The Town of Hilton Head Island Regular Design Review Board Meeting

AGENDA

DESIGN TEAM/ DRB COMMENT SHEET

PROJECT Ocean Walk Villas Phasing Plan DRB# DR070089

NEW COVERED OUTDOOR DINING FOR: DATE: 01.28.11
 ISLAND FLATEREAD-BEACH MARKET
 WILLIAM VITTO/ARCHITECT 843.683.2595

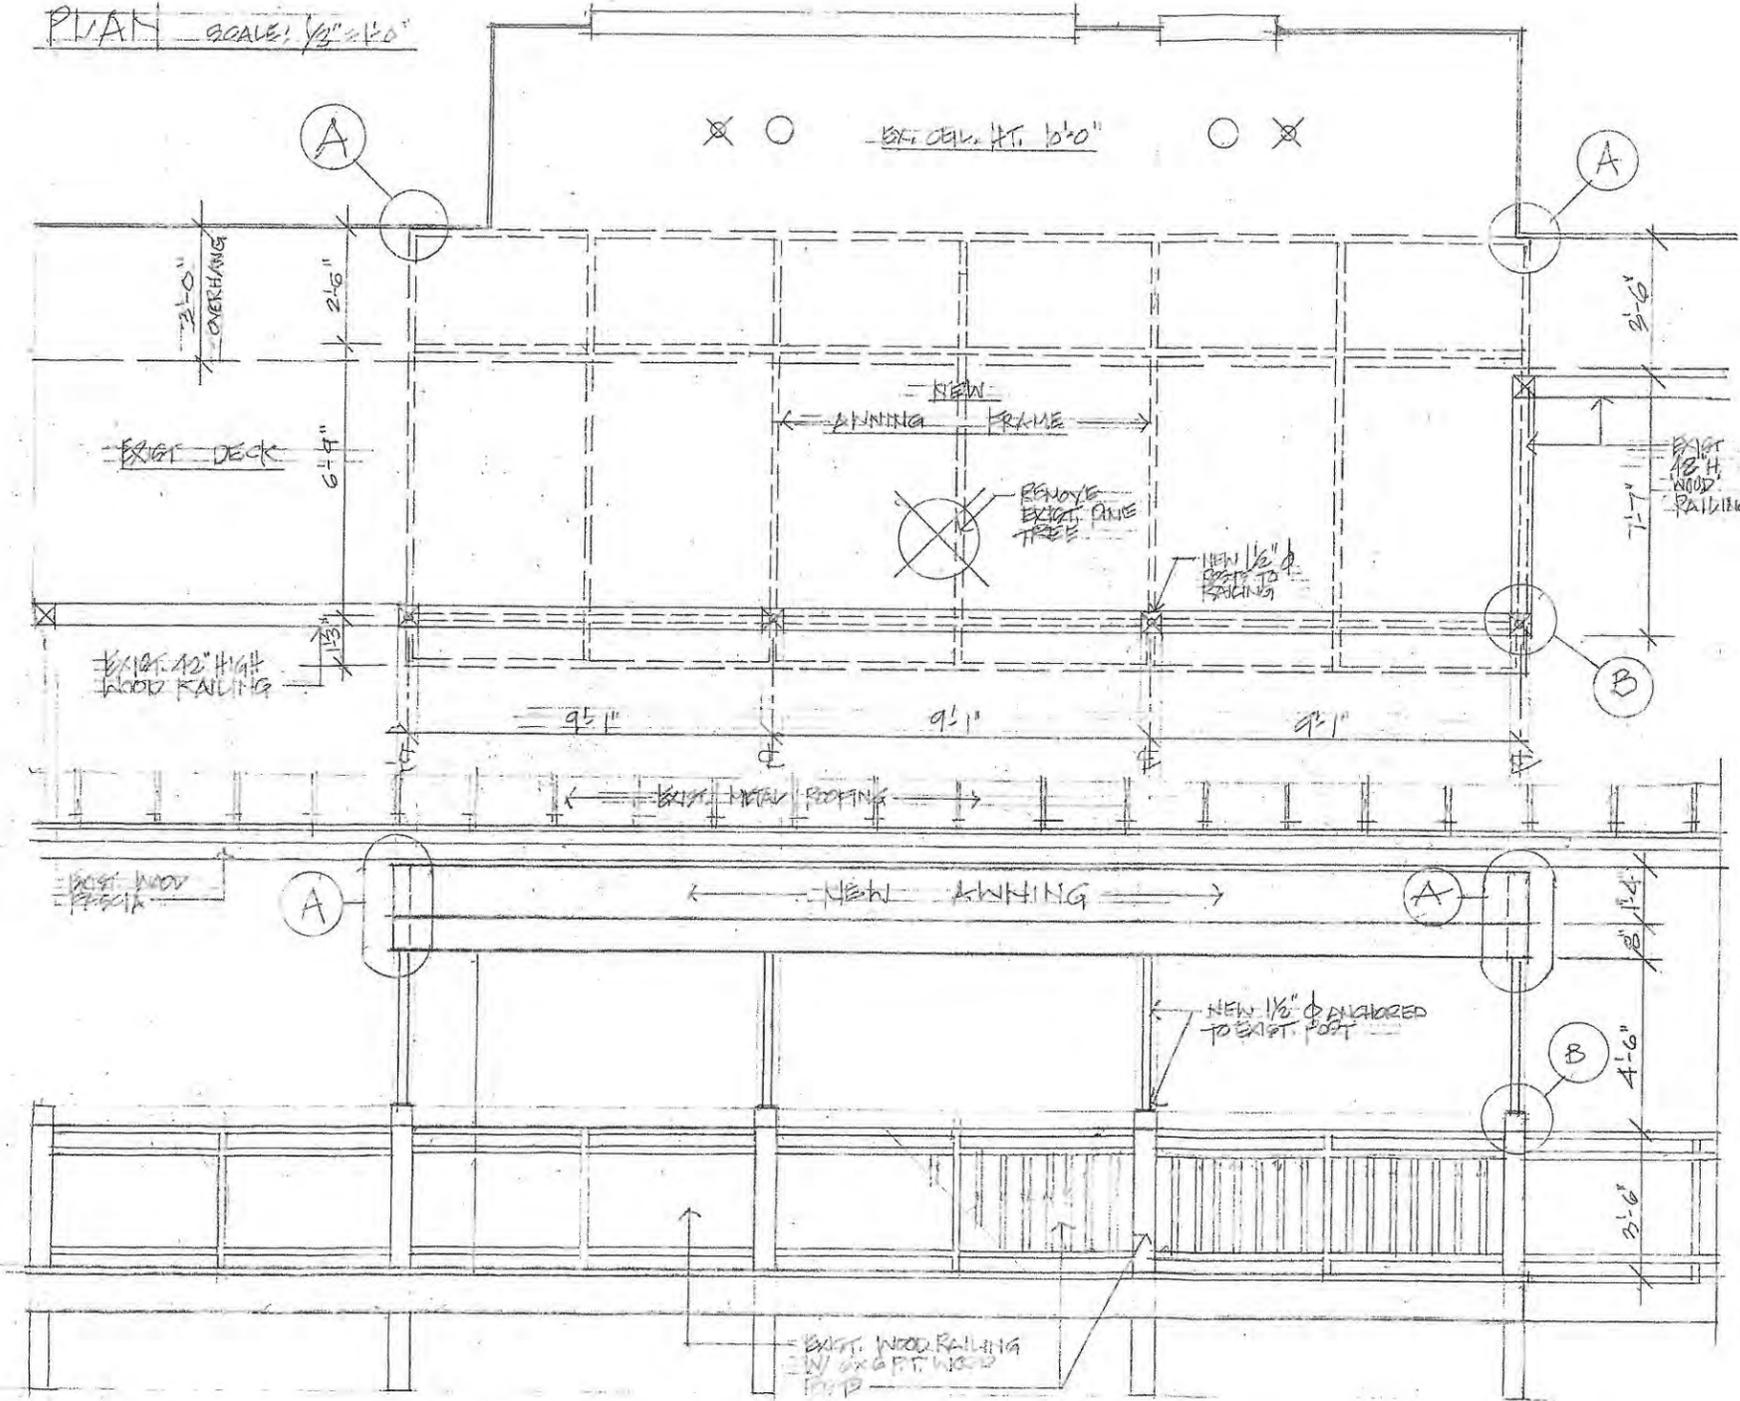
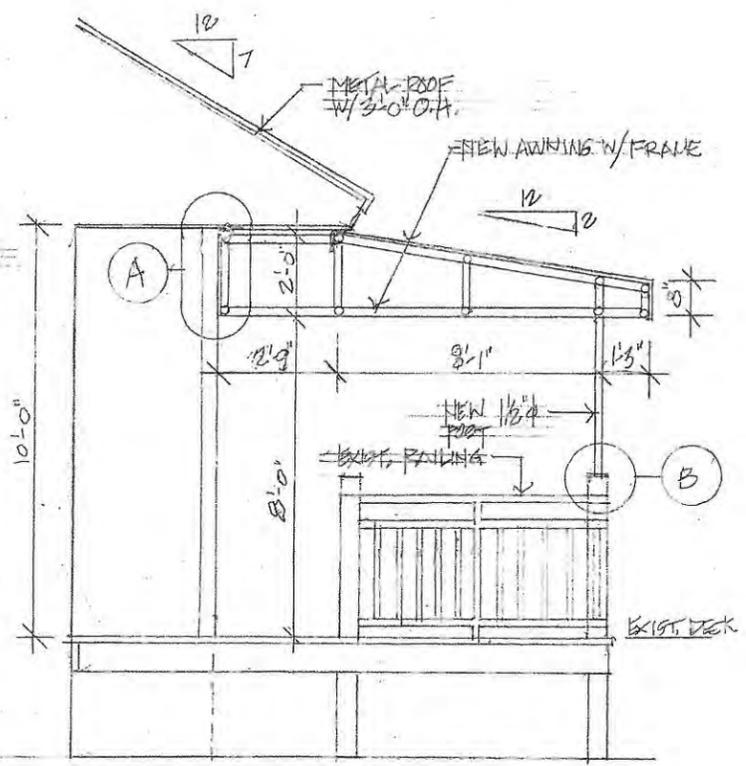
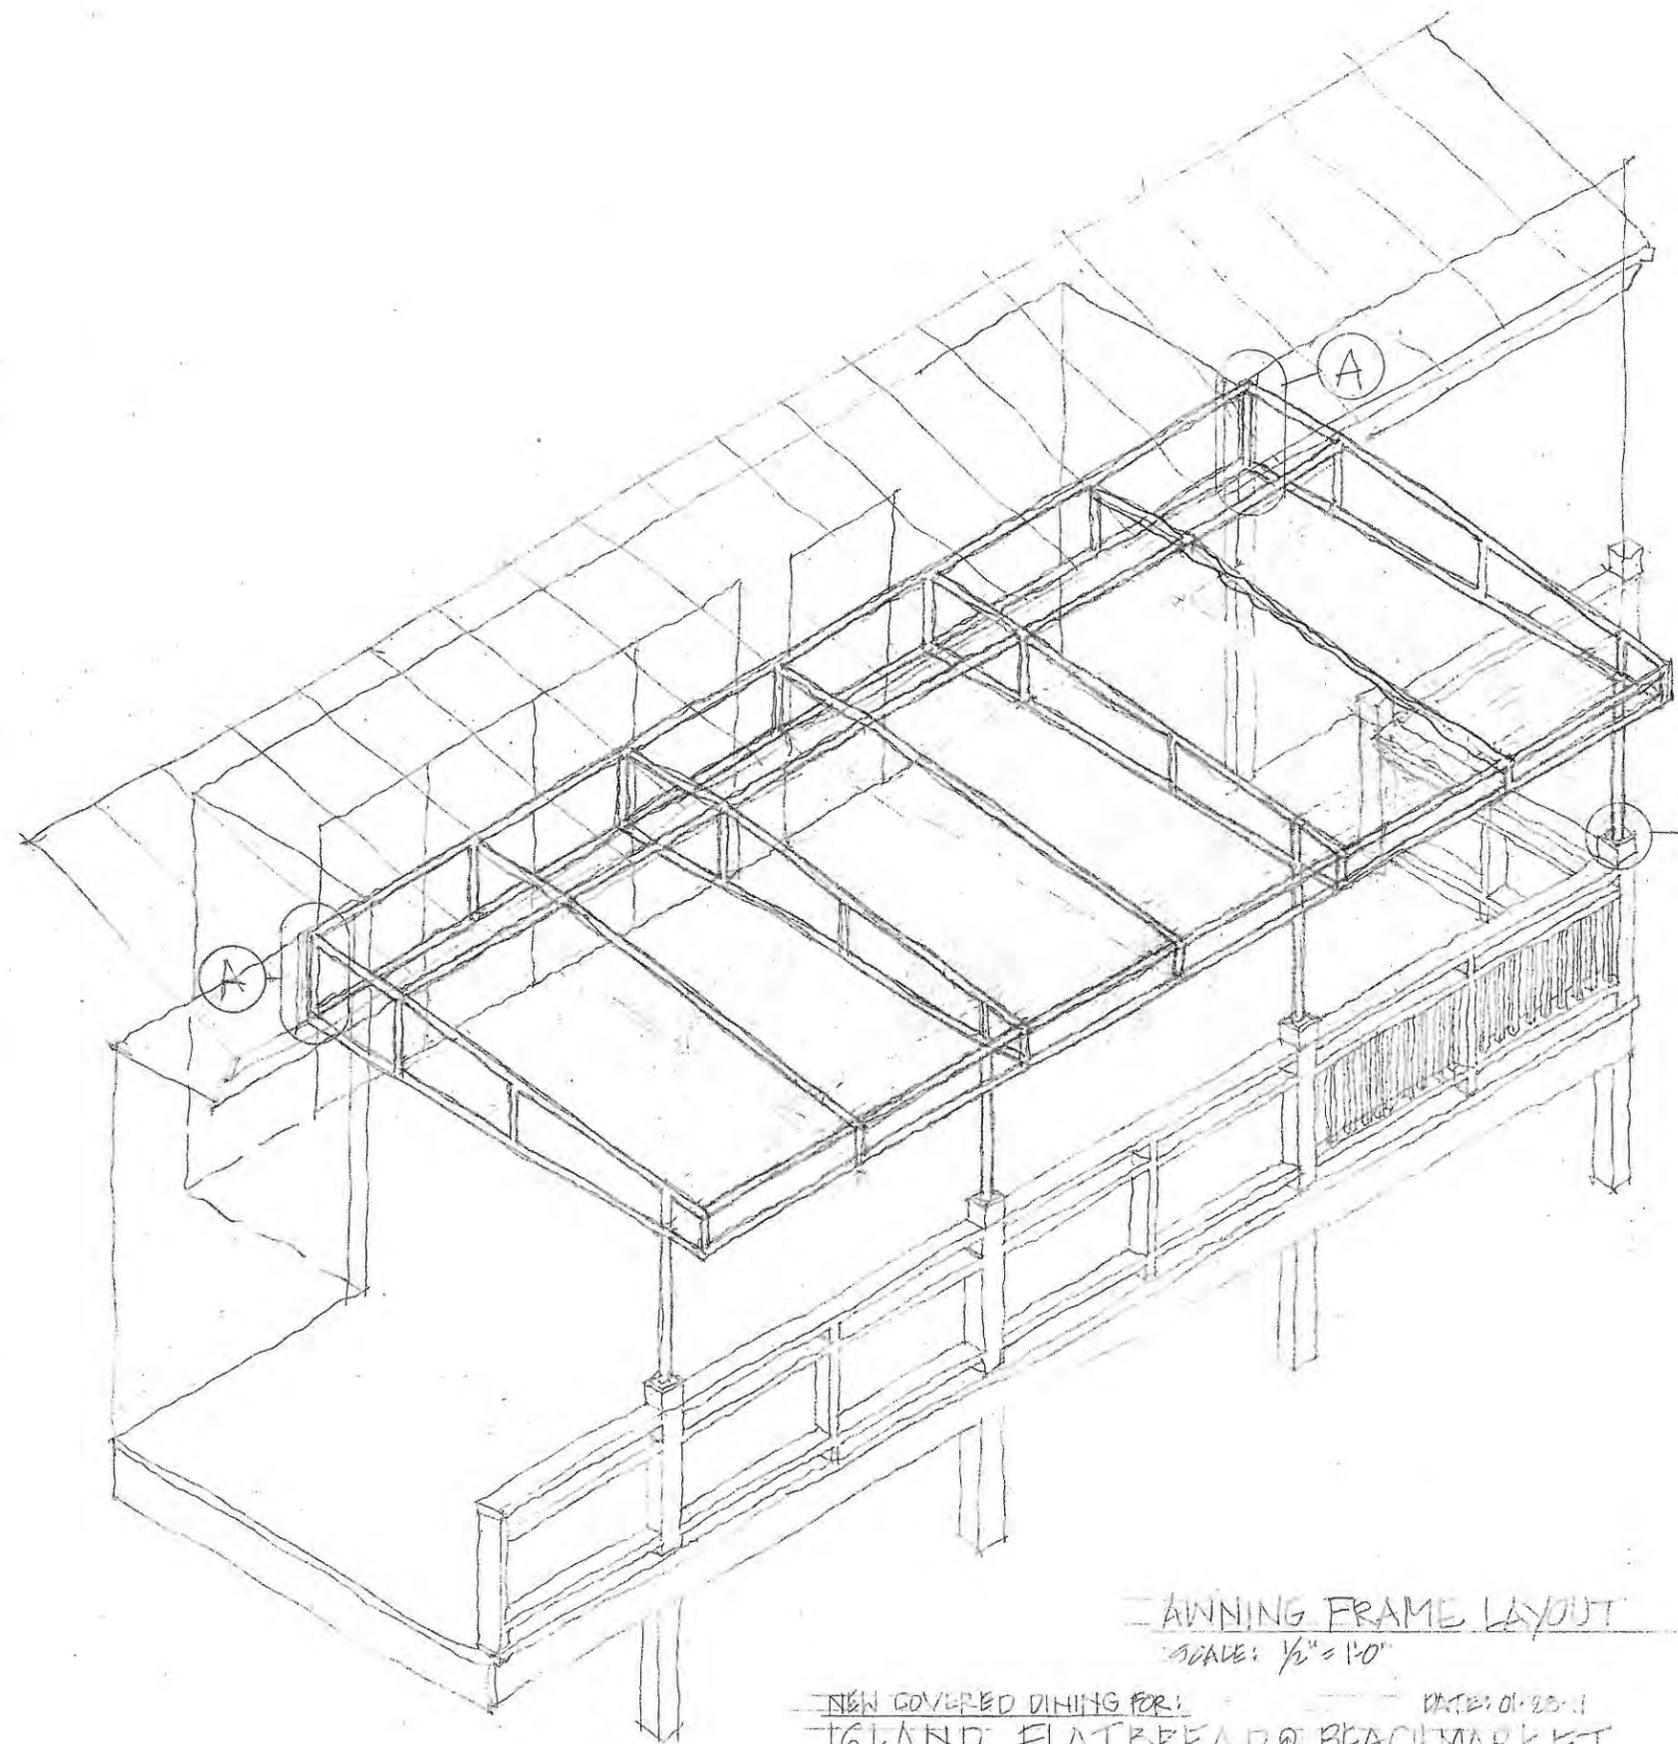
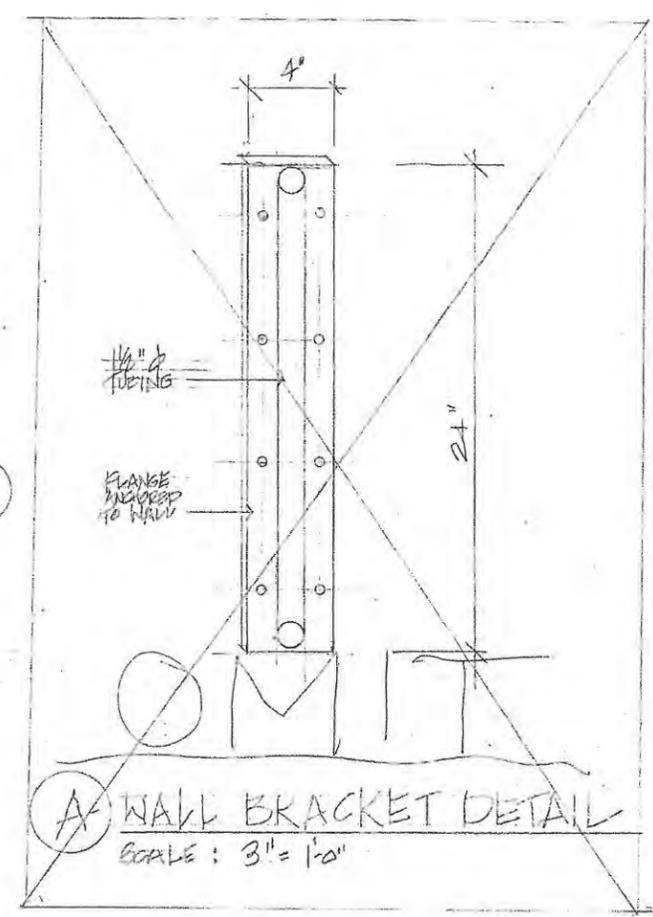
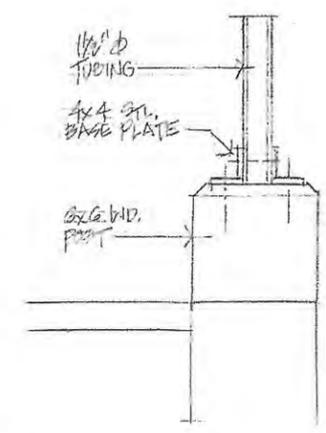
All details and finishes to match earlier approved awning (applicant still needs to submit drawings to Building Department for awnings at courtyard entry). Ends of awning will need to receive canvas to obscure tubing. Aluminum finish needs to be specified by applicant.

The addition will add function and life to an unused side of the building adjoining a public park. Issues regarding the tree are to be resolved with the Natural Resources Department, although the awnings flexible nature would allow applicant to build around the tree.

DESIGN GUIDE/LMO CRITERIA	COMPLIES YES/NO/NA	COMMENTS OR CONDITIONS
An effort has been made to preserve existing trees and under story plants	No	Pine requested for removal will require a separate approval from Natural Resources.
Supplemental and replacement trees meet LMO requirements for size, species and number		
Wetlands if present are avoided and the required buffers are maintained		
Sand dunes if present are not disturbed

CONCEPTUAL ZIP LINE ROUTE AS LAID OUT IN THE FIELD JAN. 24, 2011

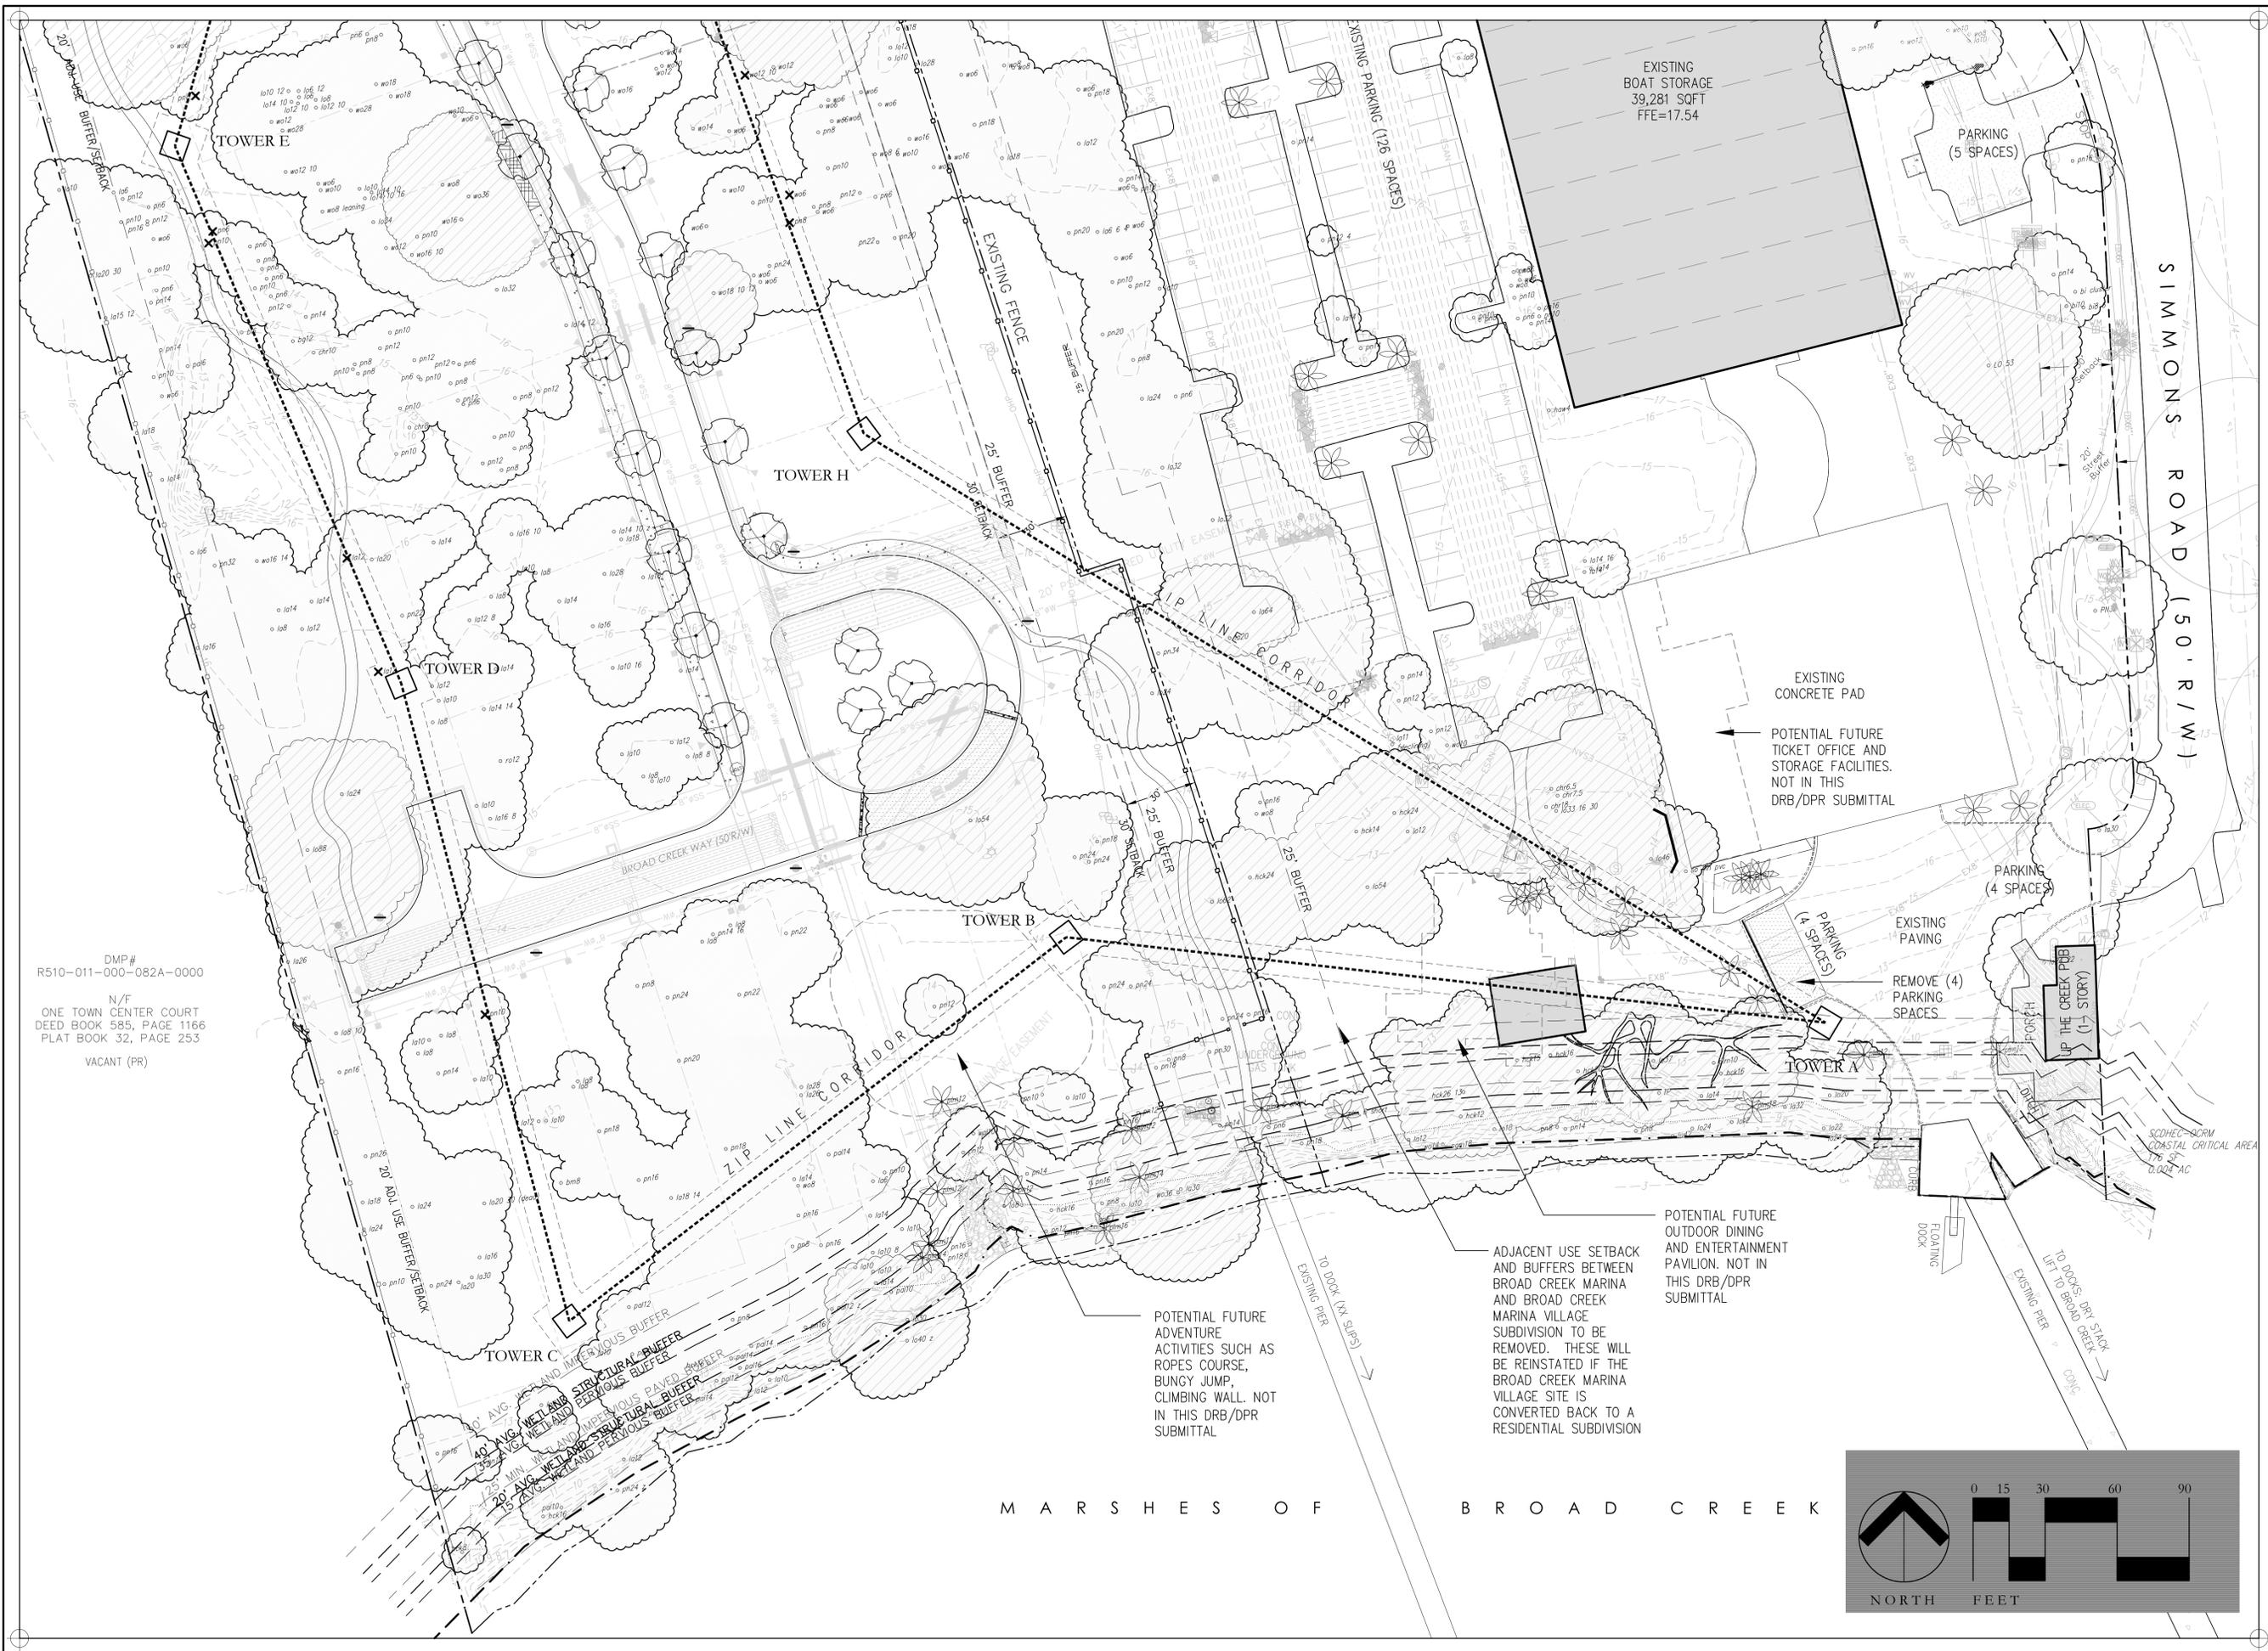
DESIGN GUIDE/LMO CRITERIA	COMPLIES YES/NO/NA	COMMENTS OR CONDITIONS
An effort has been made to preserve existing trees and under story plants		Decisions on whether or not a specimen tree will be pruned for zip line or platform clearance must be made in the field by the Natural Resources Administrator. The applicant is encouraged to locate all towers outside the driplines of these trees.
Supplemental and replacement trees meet LMO requirements for size, species and number		
Wetlands if present are avoided and the required buffers are maintained		
Sand dunes if present are not disturbed
